UNITED STATES PATENT AND TRADEMARK OFFICE

APPLICATION NO.	FILING DATE	FIRST NAMED INVENTOR	ATTORNEY DOCKET NO.	CONFIRMATION NO.
10/708,800	03/26/2004	Joy P. Prabhakaran	H0005591	2799
128	7590	06/20/2005	EXAMINER	
HONEYWELL INTERNATIONAL INC. 101 COLUMBIA ROAD P O BOX 2245 MORRISTOWN, NJ 07962-2245			ASSOUAD, PATRICK J	
			ART UNIT	PAPER NUMBER
			2857

Office Action Summary	Application No. 10/708,800	Applicant(s) PRABHAKARAN ET AL.	
	Examiner Patrick J. Assouad	Art Unit 2857

DETAILED ACTION

FIG. 2

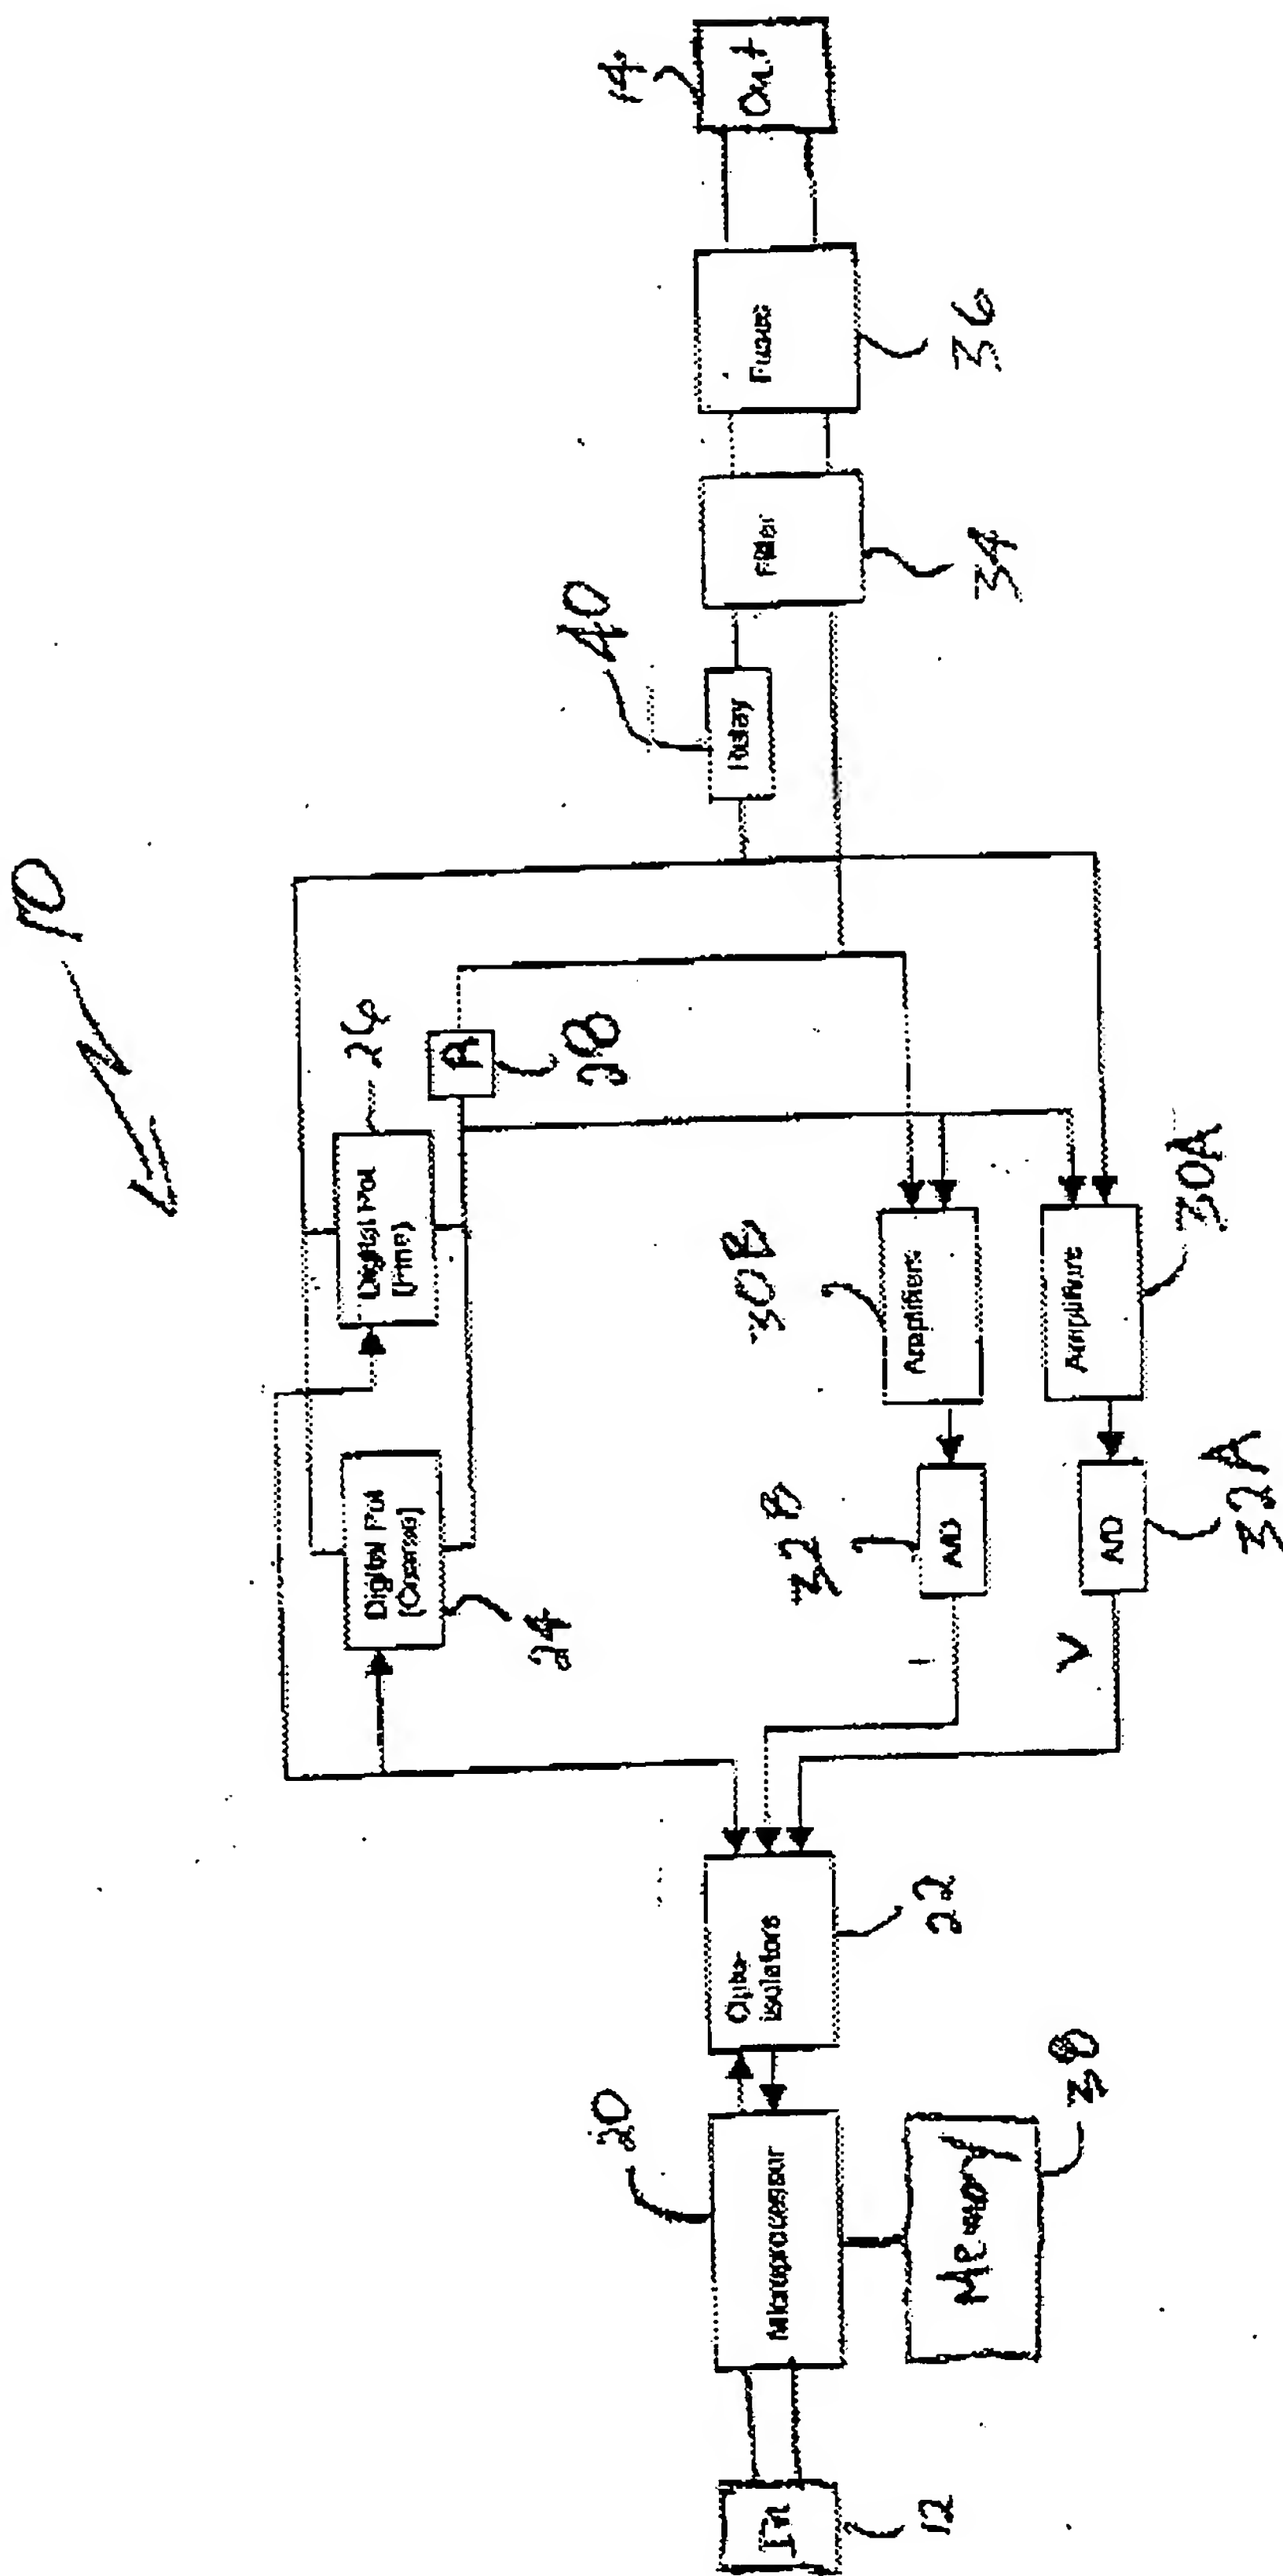
9. Claims 1-6 and 8-12 are rejected under 35 U.S.C. 102(e) as being anticipated by Gruszecki et al. (US 2004/0252750 A1) filed 6/12/03 and published 12/16/04. Note that Fig. 2 of Gruszecki et al. is reproduced below.

10. As per independent claim 1 which is simply a "plurality of digital potentiometers connected in parallel," see at least Fig. 2 of Gruszecki et al. and also the following passages from Gruszecki et al.:

12. As per dependent claims 3 and 9 which refers to a "control block" and in claim 9, a "processor," see at least para. 0005 of Gruszecki et al. which discusses the controller aspects which includes a microprocessor (see Fig. 2):

14. As per dependent claims 6 and 12 which refer to a series resistor, see at least current sense resistor 28 or the resistance provided by filter 34 or other series resistances provided for in Fig. 2 of Gruszecki et al.
